STAFF'S  
REQUEST ANALYSIS  
AND  
RECOMMENDATION

03PR0338

Ron Evans  
(Salisbury West Office Park, Phase I)

**REQUEST:** Site plan approval in conjunction with a reduction of the required 50 foot buffer adjacent to residentially zoned property.

**FRONT ELEVATION**

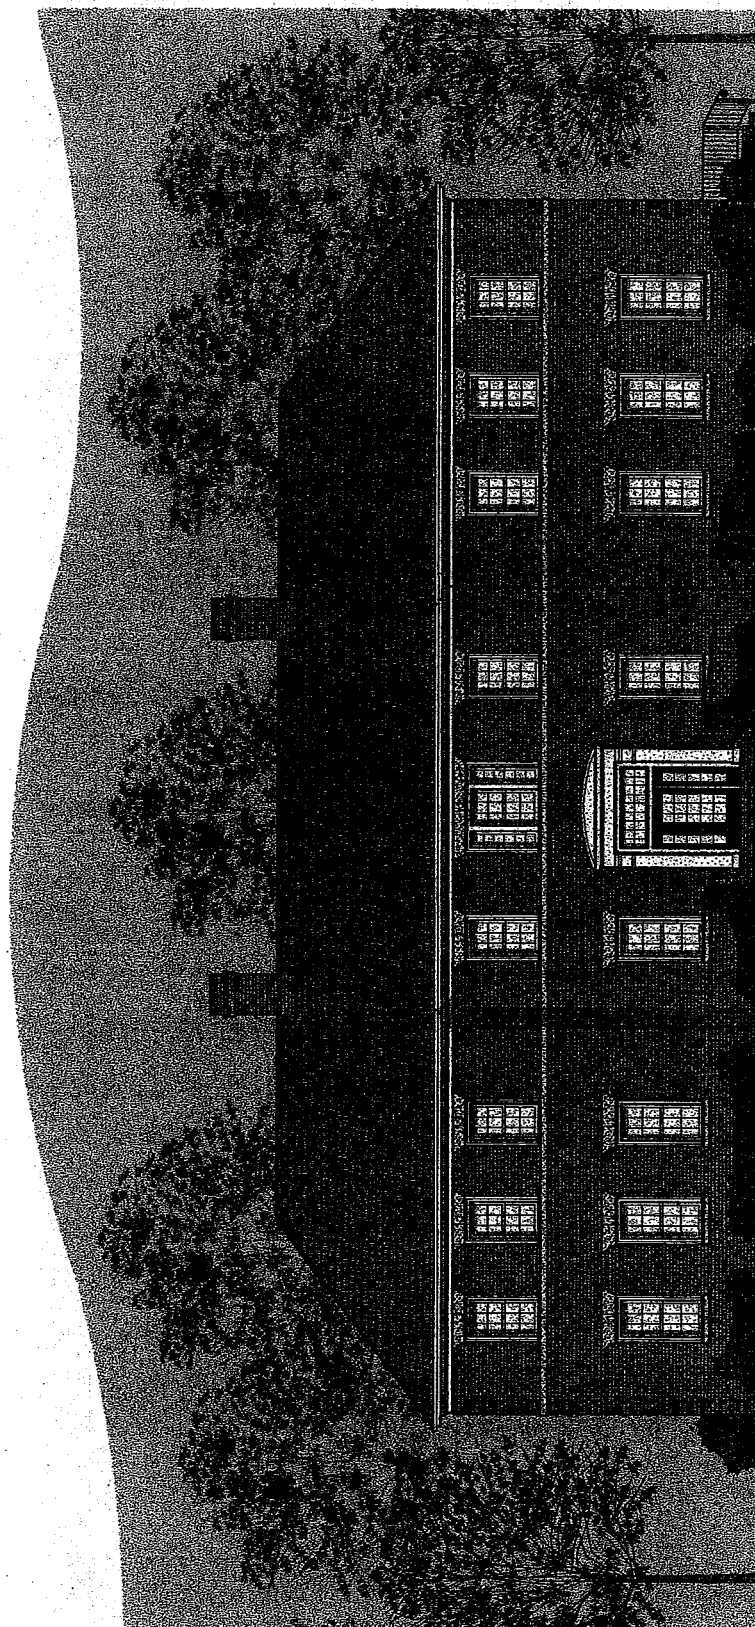
1. The applicant is the developer of the multifamily and office park projects, and is in a position to establish and maintain a buffer that uses land area from both projects.
2. The proposed office project will have a colonial theme with a residential scale so the appearance of the project will mitigate the impact on the multifamily site.
3. The site plan and landscape plan show steps being taken to maximize and supplement the vegetation in the reduced buffer as well as install a solid polyvinyl chloride (PVC) board fence.
